TRICONEX TOPICAL REPORT

7286-545-1-A

**NUCLEAR QUALIFICATION OF TRICON
TRIPLE MODULAR REDUNDANT PLC SYSTEM**

SUBJECT: REVIEW OF TRICONEX CORPORATION TOPICAL REPORTS 7286-545,
"QUALIFICATION SUMMARY REPORT" AND 7286-546, "AMENDMENT 1 TO
QUALIFICATION SUMMARY REPORT," REVISION 1 (TAC NO. MA8283)

Figure 5. Seismic Test Accelerations

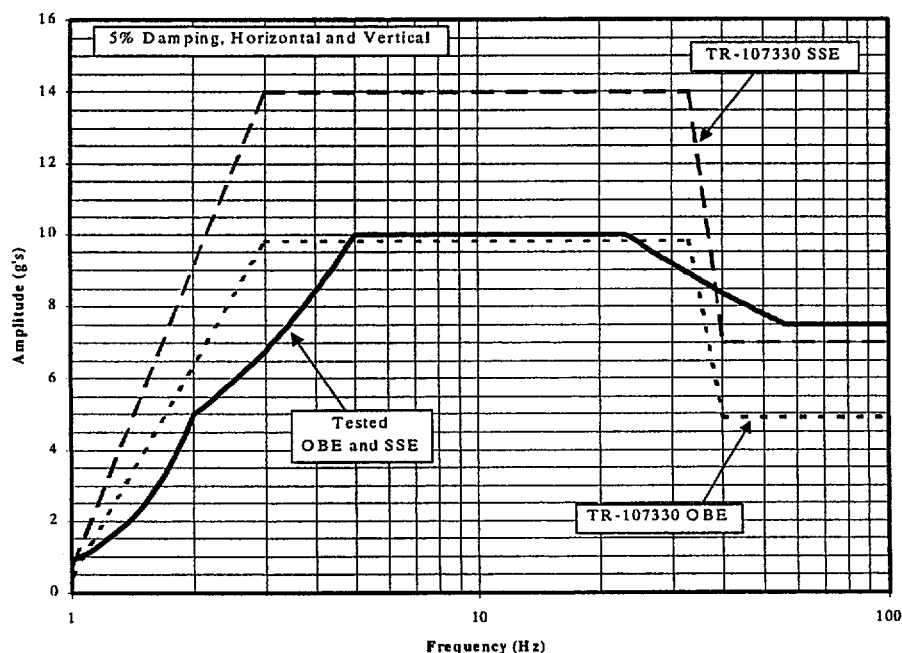
On the basis of this review, the staff concludes that the tested Tricon PLC system equipment and third-party field power supply are qualified to the triaxial seismic simulator table limits shown in Figure 4-2 of EPRI Technical Report 1000799, with the exception of the maximum acceleration of an SSE. For this reason the staff finds that the Tricon PLC system did not fully meet the requirements of EPRI TR-107330 for seismic requirements, and before using Tricon PLC system equipment in safety-related systems in a nuclear power plant, licensees must determine that the plant-specific seismic requirements are enveloped by the capabilities of the Tricon PLC system. This determination, and the suitability of the Tricon PLC system for a particular plant and application is the responsibility of the licensee.
